ROTH BROS. SMELTING CORP. CORRECTIVE MEASURES
STUDY REPORT ADDENDUM

File No. 70185-43
March 1994

Subject: Roth Bros. Smelting Corp. Corrective Measures
Study Report Addendum

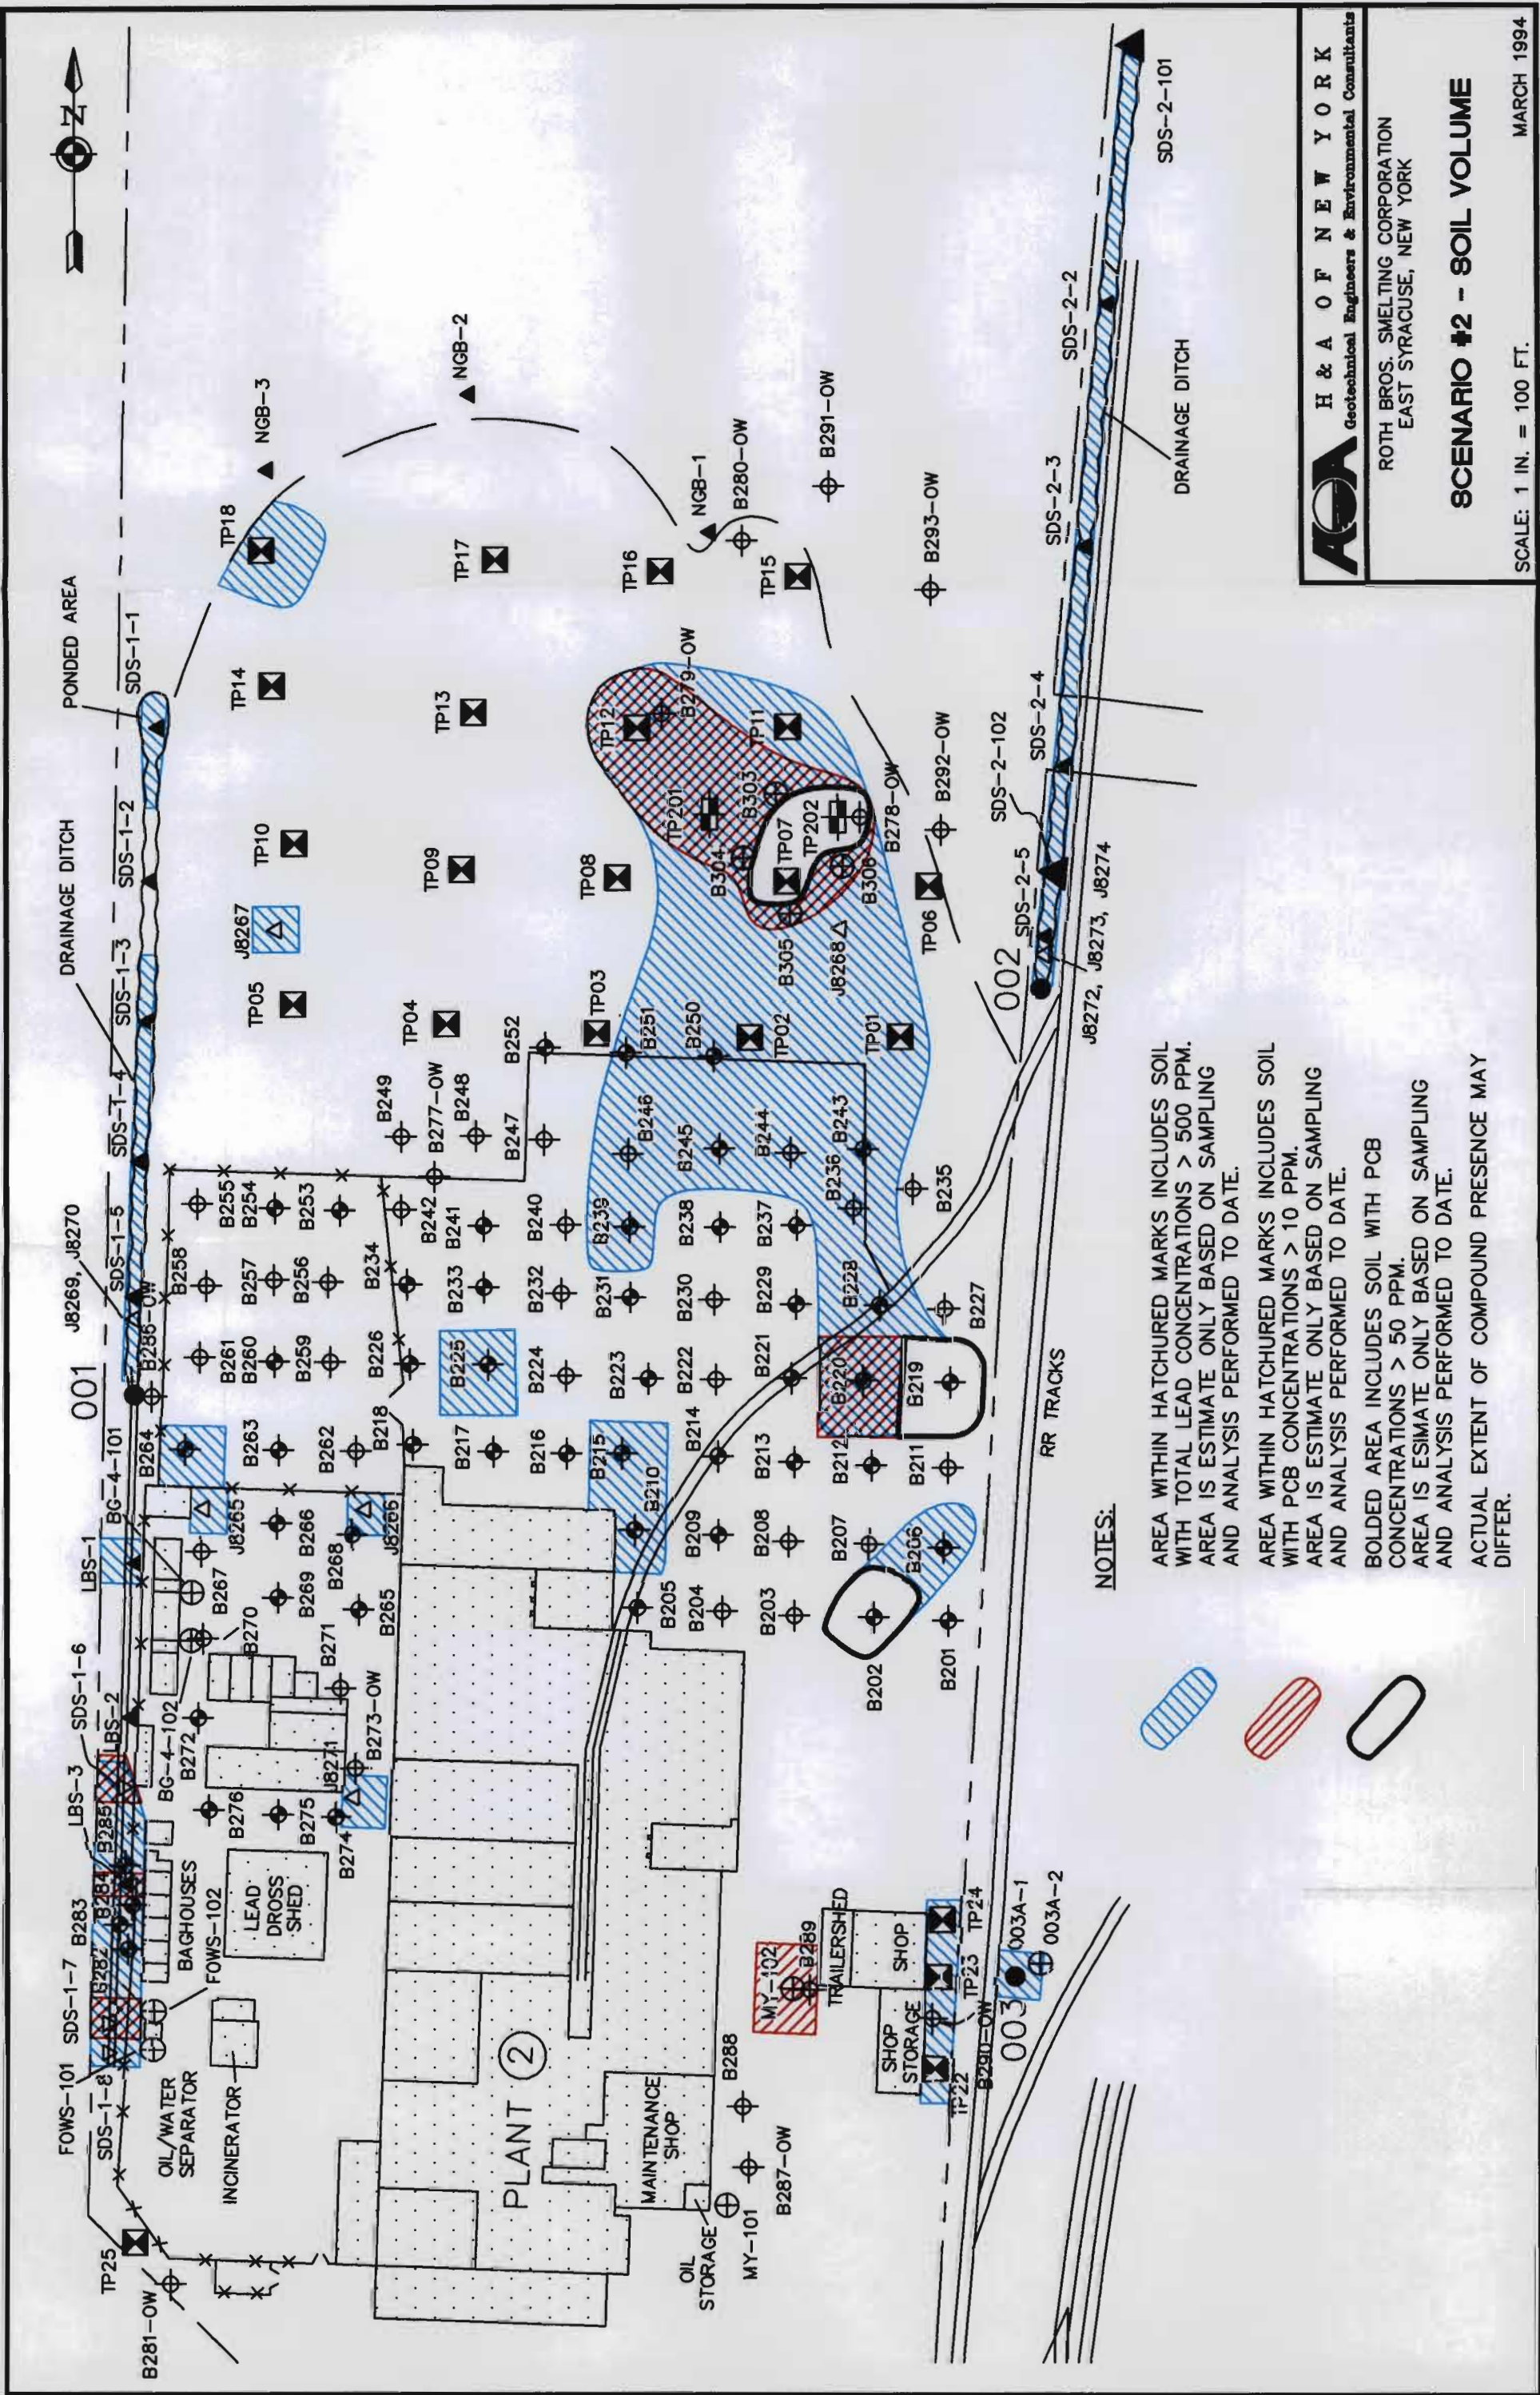
NYSDEC COMMENT: "DEC reserves comment on Section 3-04. until the New York State Department of Health (DOH) completes its review of the Risk Assessment calculations. To consider alternative corrective measures scenarios, you must perform three (3) soil volume calculations: 1) Pb at 250 ppm and PCBs at less than 1.0 ppm; 2) Pb at 500 ppm and PCBs at 10 ppm; and 3) Pb at 825 ppm and PCBs at 25 ppm. This will allow cost comparisons of different cleanup levels for each alternative. Please include the actual calculations used to arrive at the various soil volumes in the CMS addendum."

Using Figures 1 through 3 estimated soil volumes were calculated using each of the three sets of concentration criteria as listed above. Volumes were determined for both total lead and PCBs for each of the three scenarios. See Table I for a summary of these volumes. The actual calculations used to obtain the various soil volumes are located in Appendix A.

When comparing total volumes using cleanup criteria of total lead >500 ppm and PCBs at >10 ppm rather than lead at >825 and PCBs >25 ppm, there is an overall increase in total volumes of 3,680 tons or 18% (areas included are shown on Figure 2). This 18% increase in total volume translates into an estimated 13% increase in treatment costs alone, with total costs ranging from \$1,824,184 to \$1,994,864 (refer to Table I).

And finally, a 62% or 12,911 ton increase of total volume occurs when using lead at >250 ppm and PCBs at >1.0 ppm rather than lead at >825 ppm and PCBs at >25 ppm (affected areas are shown on Figure 1). This 62 % increase in total volume translates into an approximate 45% increase in treatment costs alone, with total costs ranging from \$2,340,672 to \$2,511,352, (refer to Table I).
